CONSIDER AN APPLICATION FOR SPECIAL USE PERMIT MODIFICATION FOR UNIVERSITY PLACE, 201 S. ESTES DRIVE (PROJECT # 19-130)

SUMMARY REPORT

PROPERTY ADDRESS 201 S. Estes Drive	MEETING DATE June 9, 2021	APPLICANT Jessie Hardesty, McAdams, on behalf of RRPV University Chapel Hill Limited Partnership
---	-------------------------------------	---

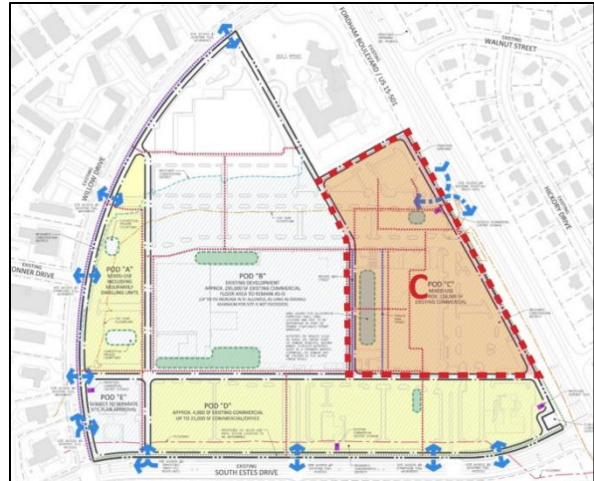
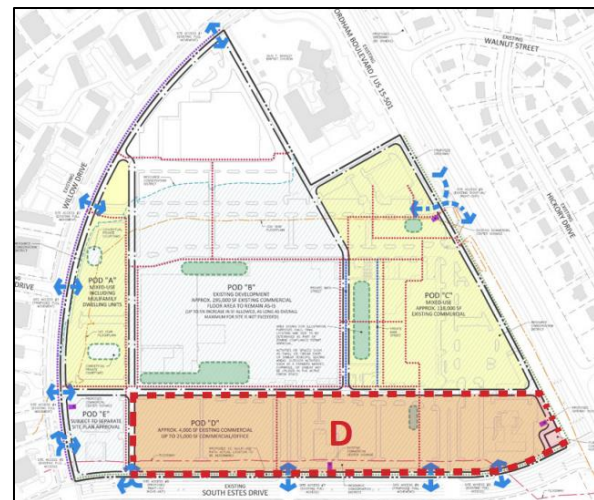
- New constructed stand-alone buildings shall be more than one story in height.

Building Heights: Any new stand-alone building, to be constructed in Pod C, shall be constructed at a minimum height of two-story building.

Applicant Response: We have proposed requiring two story buildings only within the specified area of Pod C. This was the area where the board was requesting 2-story. Please see the diagram below indicating Pod C.
